DATE: January 29, 2018
TO: Andrew Junius
FROM: Richard Sucre, Planning Department
RE: PPA Case No. 2017-013659PPA for 140 14th Street

Preliminary Project Assessment

Date: January 29, 2018
Case No.: **2017-013659PPA**
Project Address: 140 14th Street
Block/Lot: 3530/011, 013, 032, 042, 043
Zoning: PDR-1-G (Production, Distribution & Repair – 1 – General) Zoning District
58-X Height & Bulk District
Area Plan: Mission – Eastern Neighborhoods
Project Sponsor: Andrew Junius, Reuben, Junius & Rose, LLP
(415) 567-9000
Staff Contact: Michael Christensen – (415) 575-8742
michael.christensen@sfgov.org

RE: **SDAT Review**
Case No. 2017-013659PPA, 140 14th Street
Neighborhood: Mission
Zoning: PDR-1-G (Production, Distribution & Repair-1- General)
Area Plan: Eastern Neighborhoods (Mission)

Enclosure: Preliminary Shadow Fan
SDAT Response

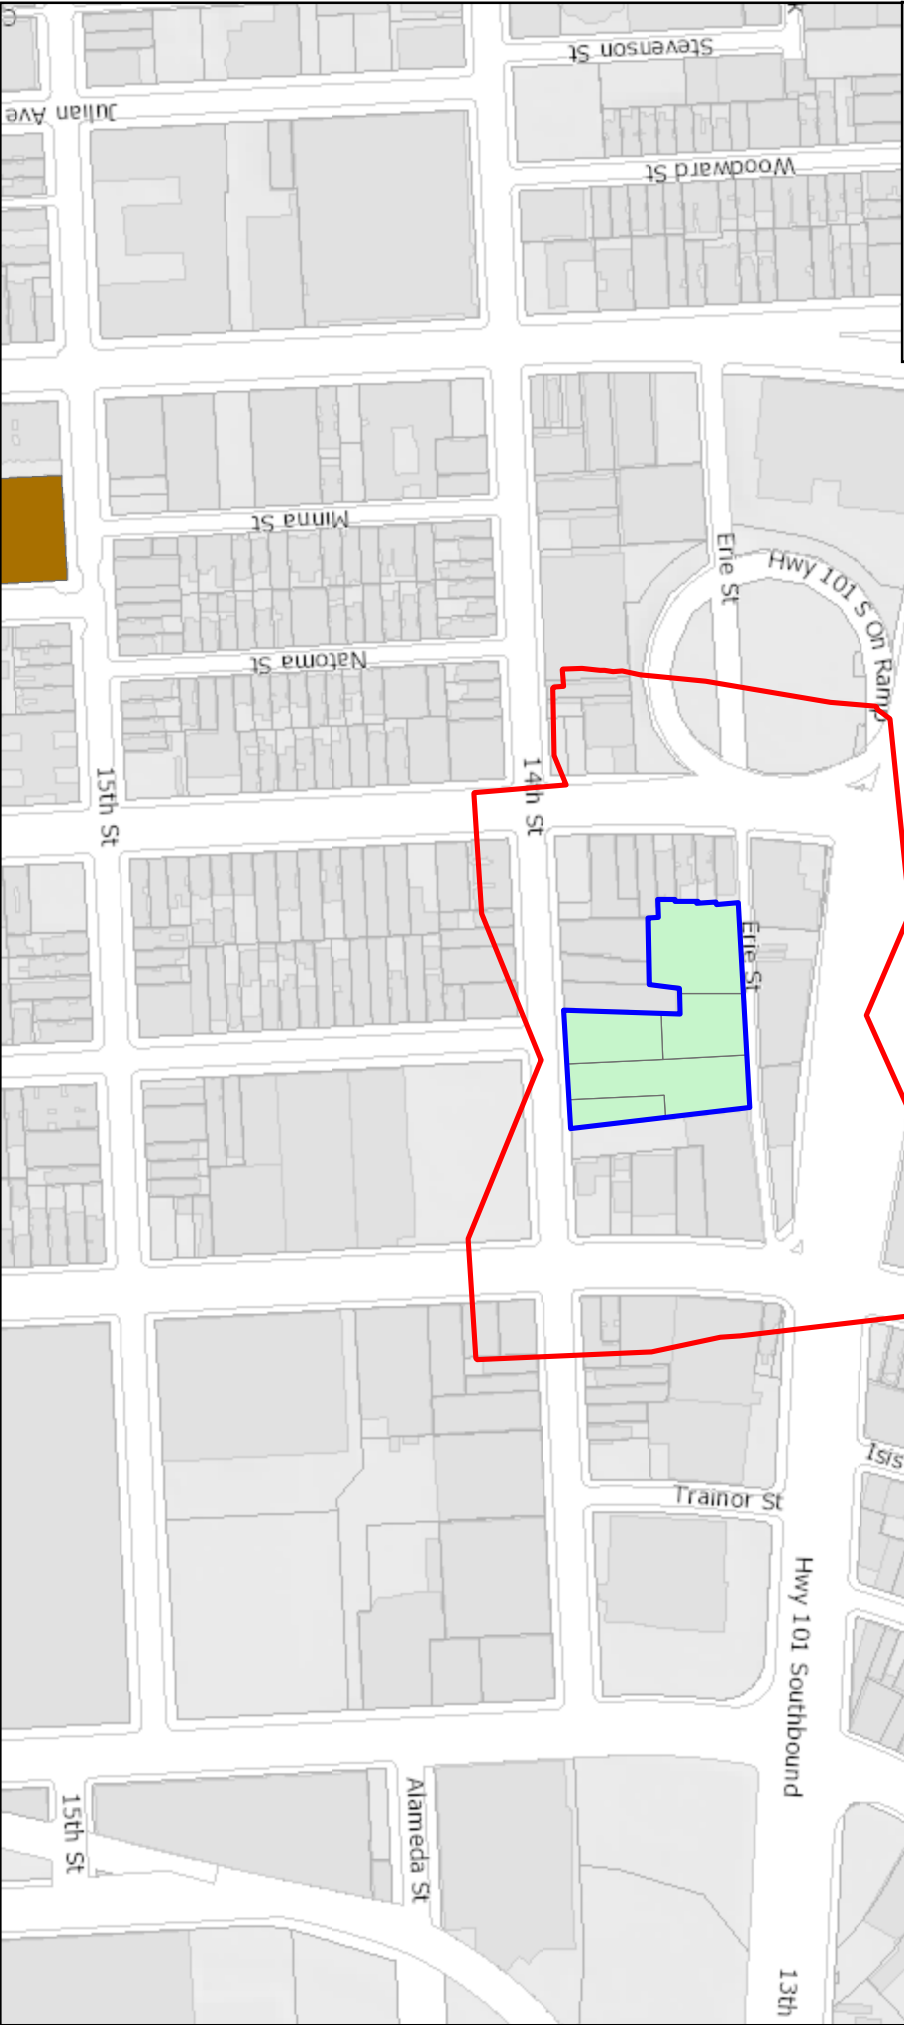
8. **Shadow.** The proposed project would result in construction of a building greater than 40 feet in height. A preliminary shadow fan analysis prepared by Planning Department staff indicates that the proposed project would not cast shadows on a Recreation and Park Department property subject to

Section 295, or other publicly accessible properties not subject to Section 295, including schoolyards. Therefore, a detailed shadow analysis is not required.
